### **Change Order**

PROJECT: (Name and address)
Raymond Community Park

Change Order Number: 04 Date: September 24, 2025

### **ASI#20 - Irrigation Changes**

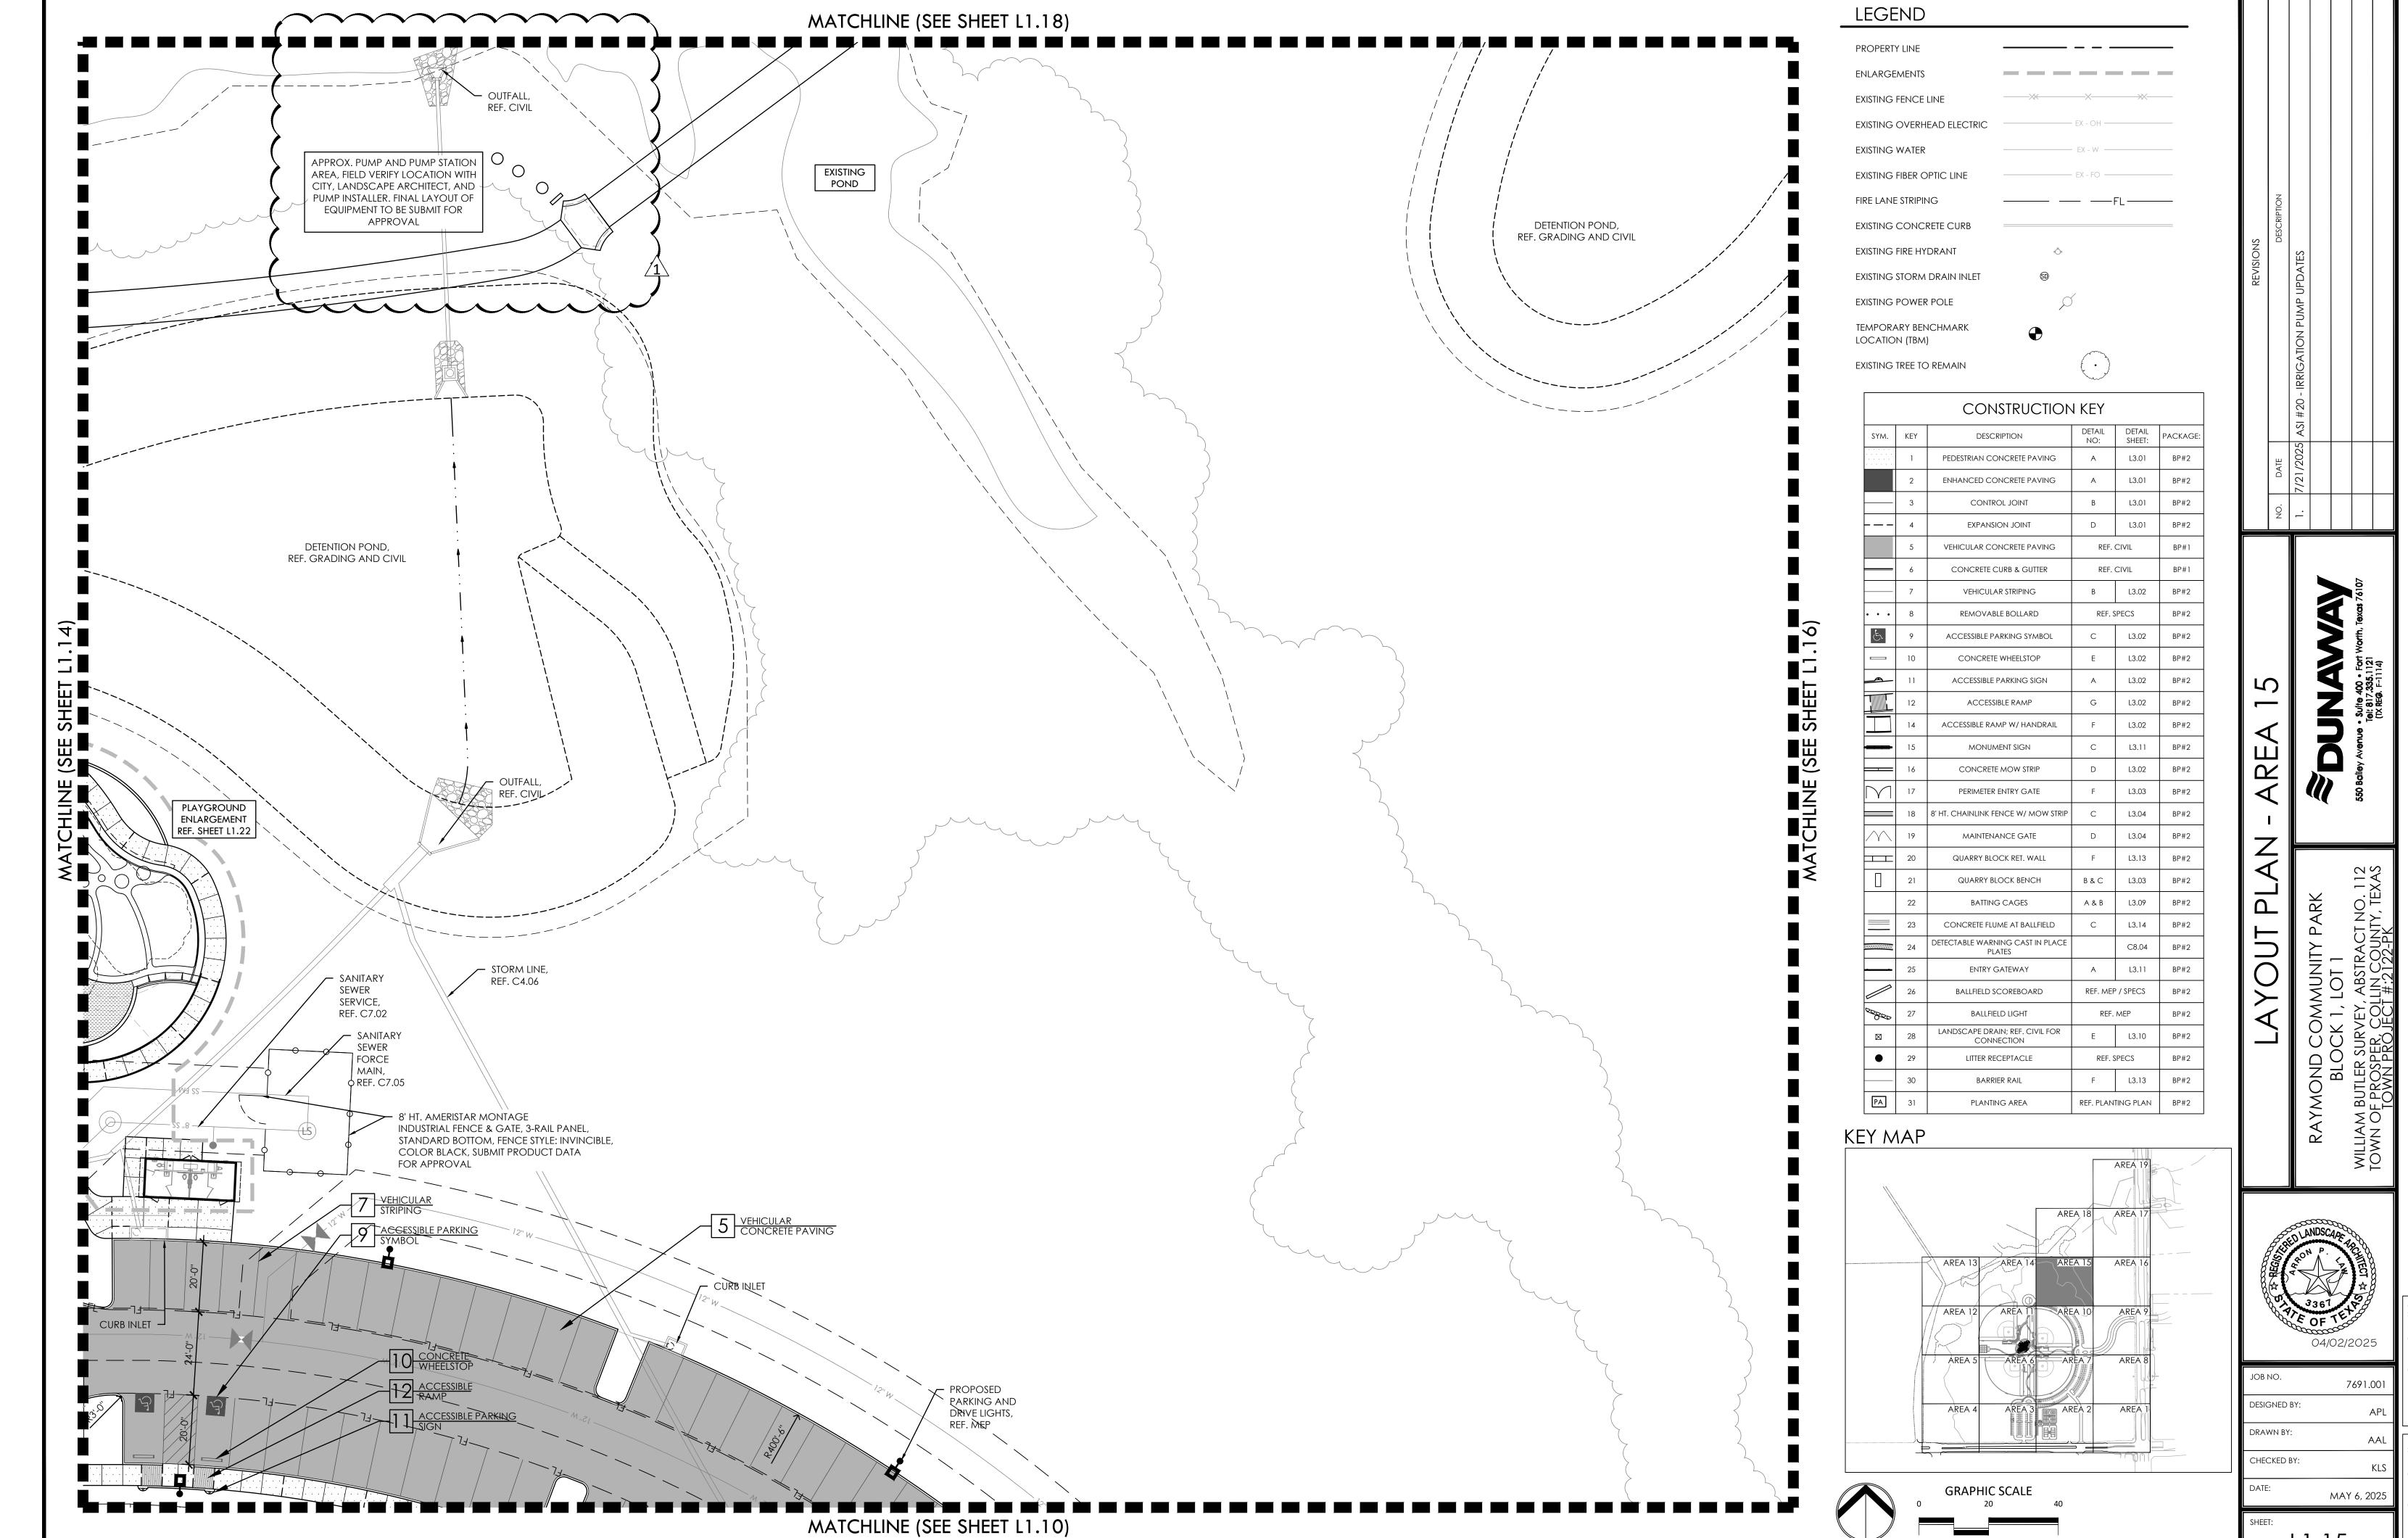
- 1. L5.00 Overall Irrigation Plan
  - Irrigation Schedule updated
  - Pumps and mainline updates
- 2. L5.01 Irrigation Plan Area 1
  - Added note for disconnection of 4" meter

- 1. Pump mainline for south east irrigation, approx. additional 1,165 lf of 4" mainline.
- 2. Pump mainline for south west irrigation, approx. additional 1,237 lf of 4" mainline.
- 3. Pump mainline for remining field & site irrigation, approx. additional 300 lf of 4" mainline
- 4. Pump mainline sleeve for sough west irrigation approx. 61 If for 4" mainline.
- 5. Removal of 4" mainline from north west side to old pump location, approx. reduction of 4" 576 of 4" mainline.

L5.01

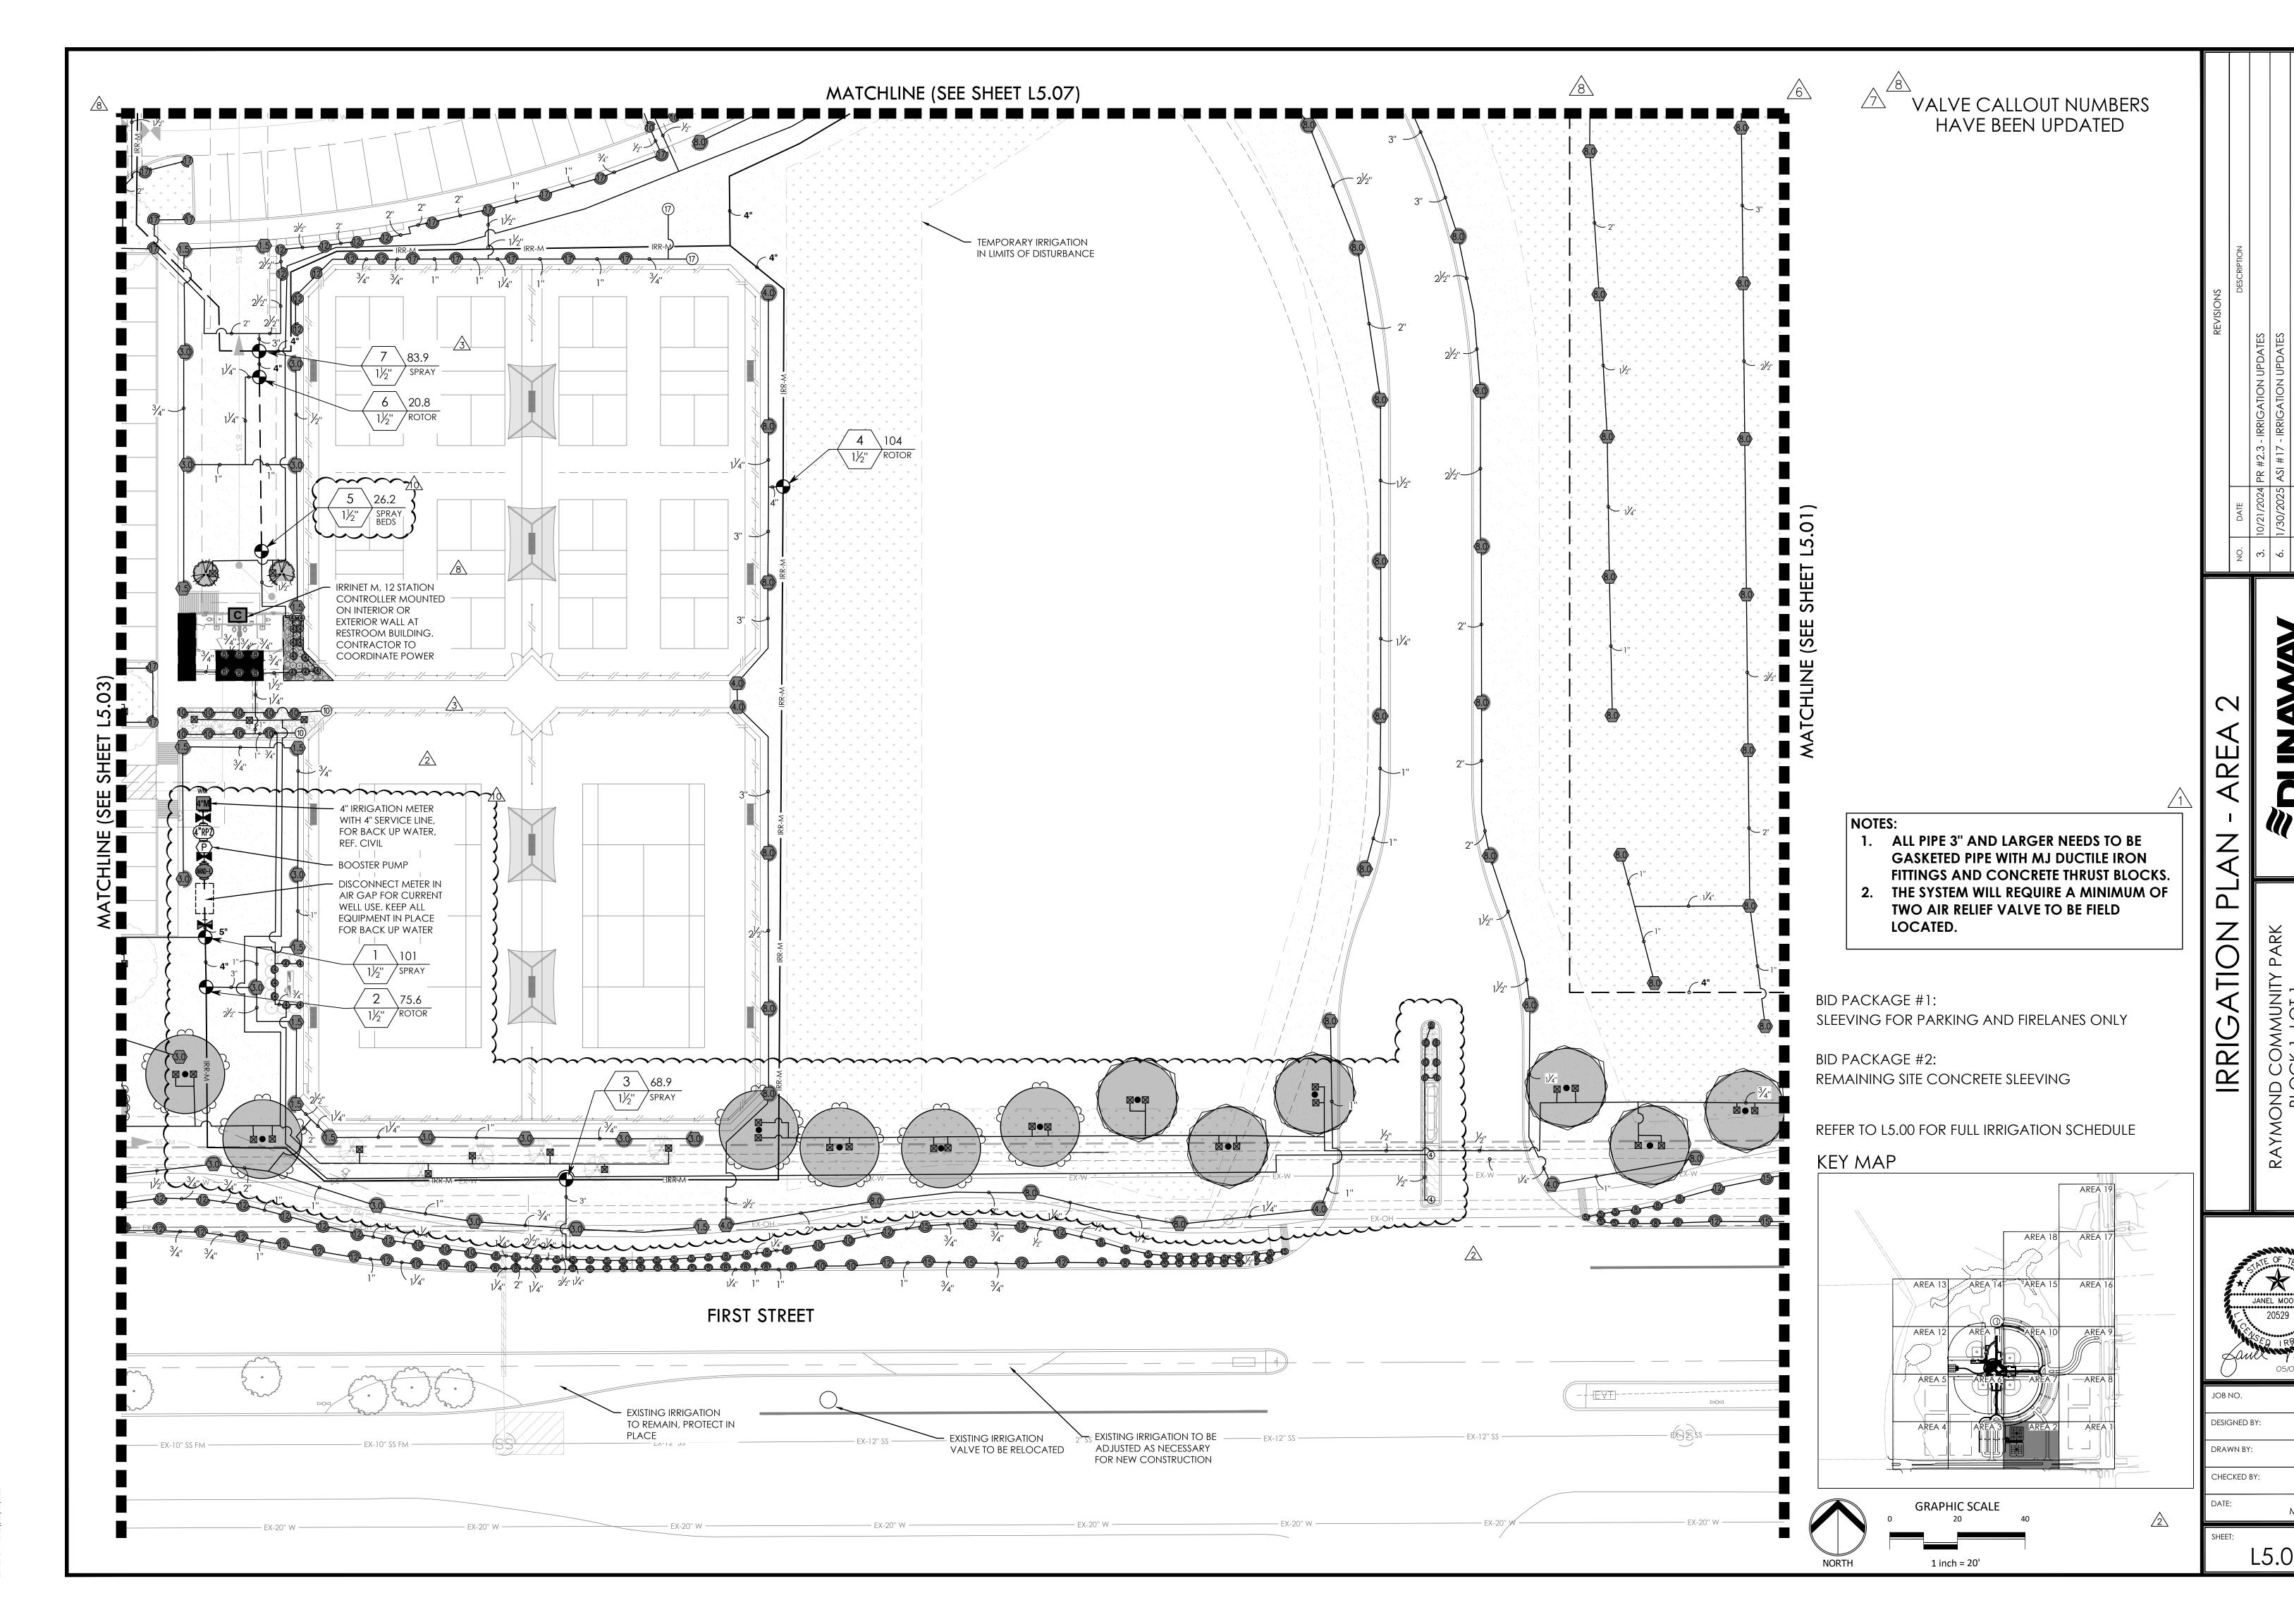
- Show mainline disconnect in air gap valve box
  - Lateral line connection from spray valve #3 to shrub bed valve #5. (RFI 063)
- 3. L5.02 Irrigation Plan Area 2

L5.08

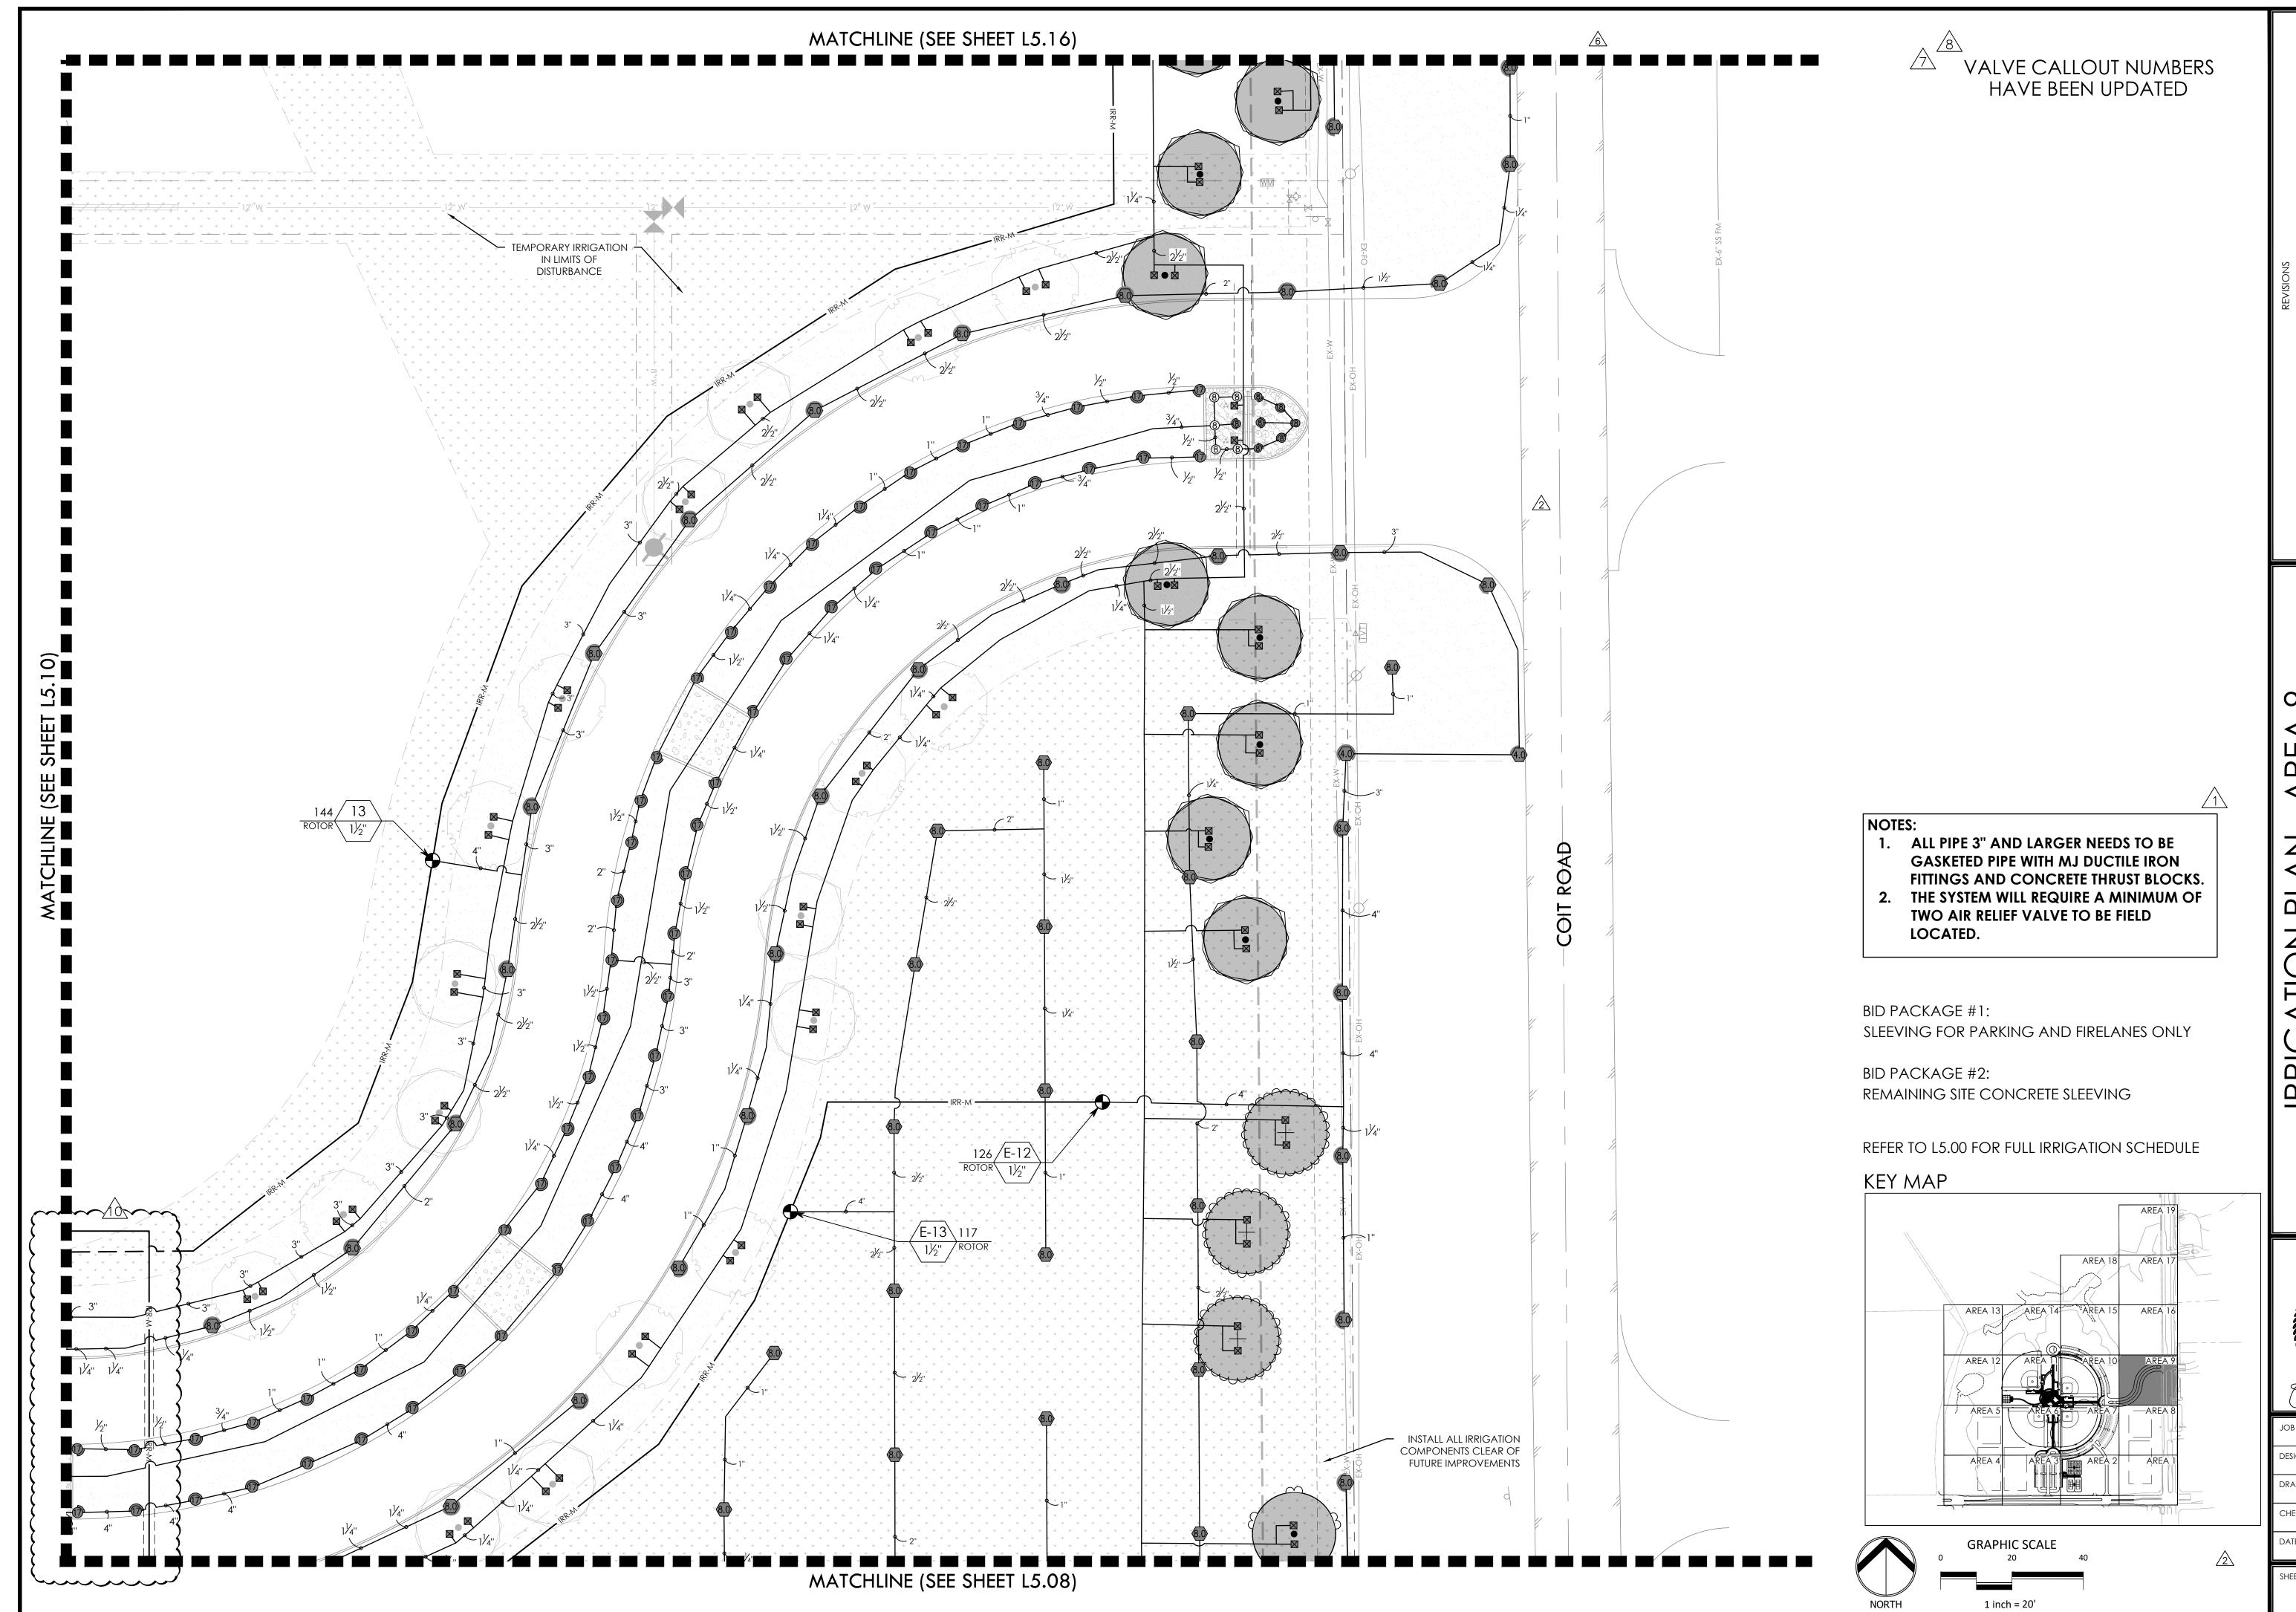
- Sow mainline disconnect in air gap valve box
- 5. L5.08 Irrigation Plan Area 8
  - Add irrigation mainline and sleeve for new north pump location
- 6. L5.09 Irrigation Plan Area 9
